Interim Reclamation and Stormwater Inspection

Operator: IMPETRO RESOURCES LLC - 10690

Location ID: 317058

Inspection Document #: 708200367

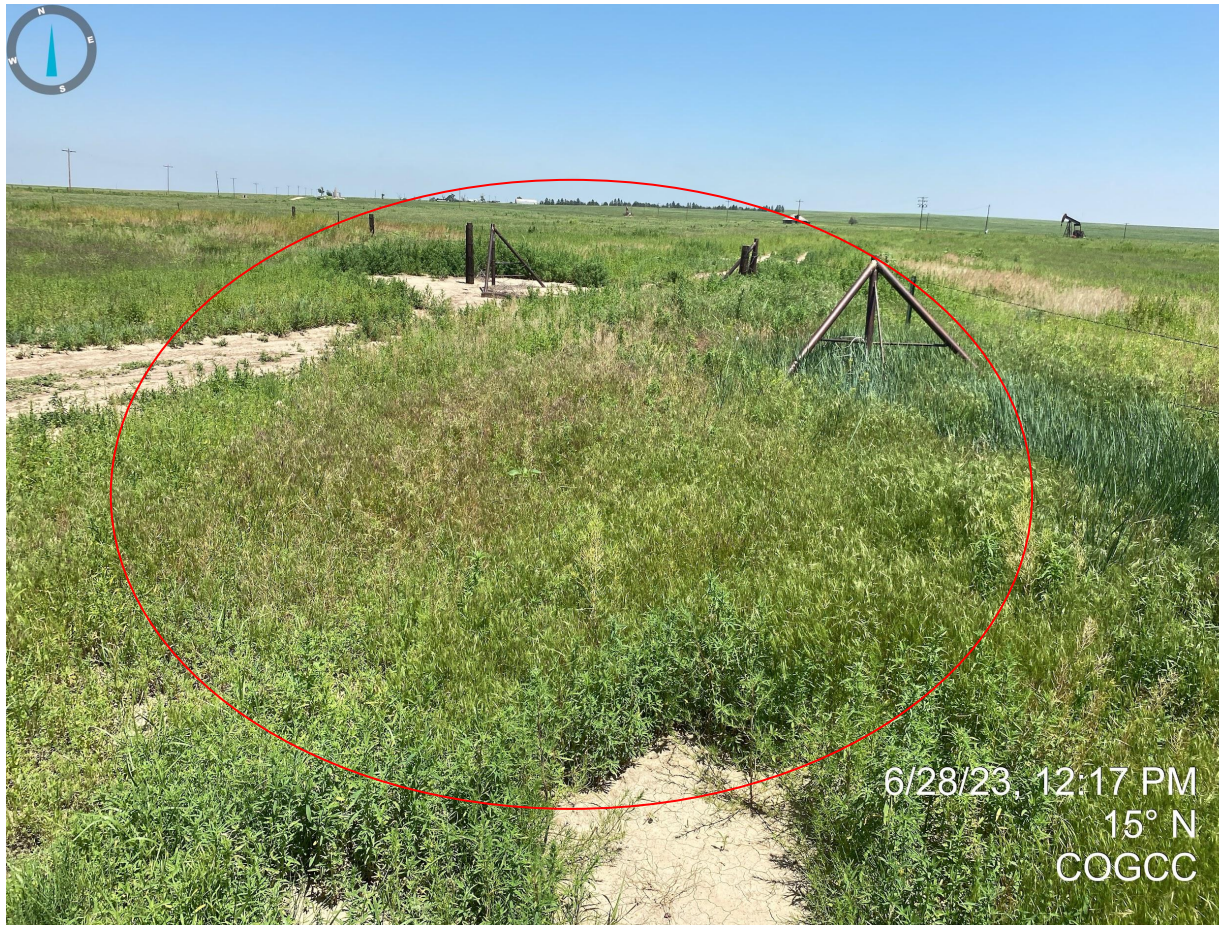
Photo 12. See comments in Photo 11.

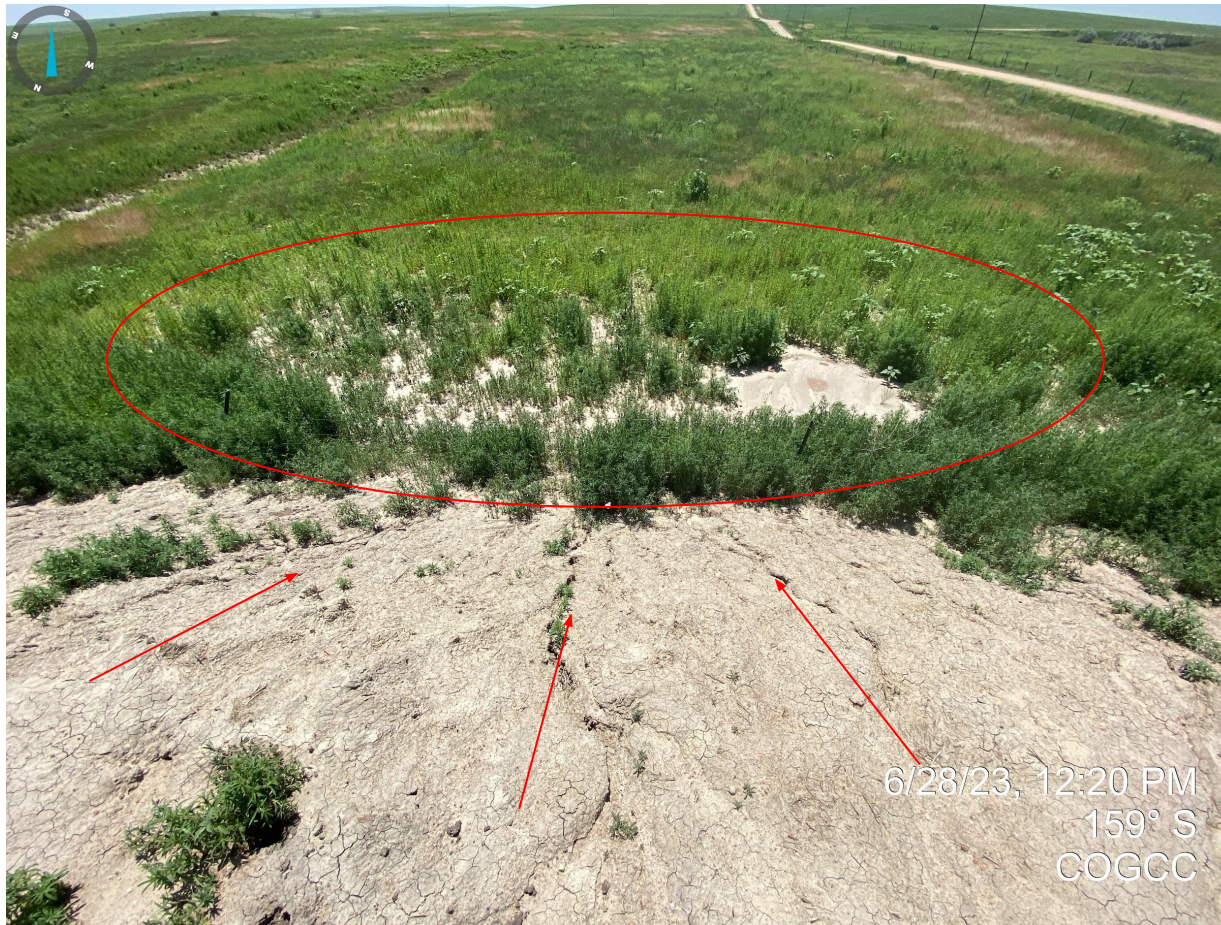
Photo 14. Debris within pit walls/berms will need to be removed and disposed of.

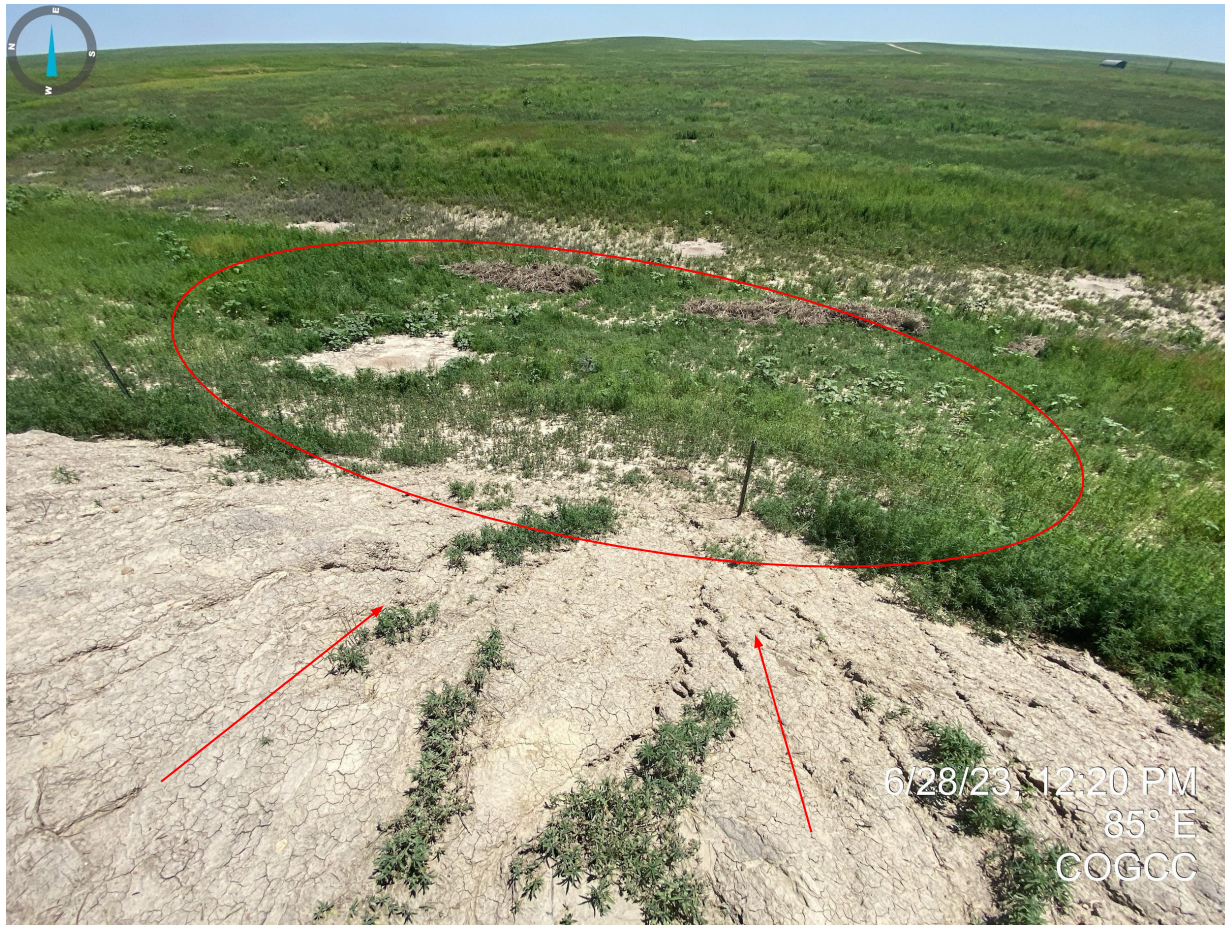
Photo 15. Southern pit wall. Evidence of rilling erosion and off-location sediment transport observed. Additional BMPs are required to stabilize the soils.
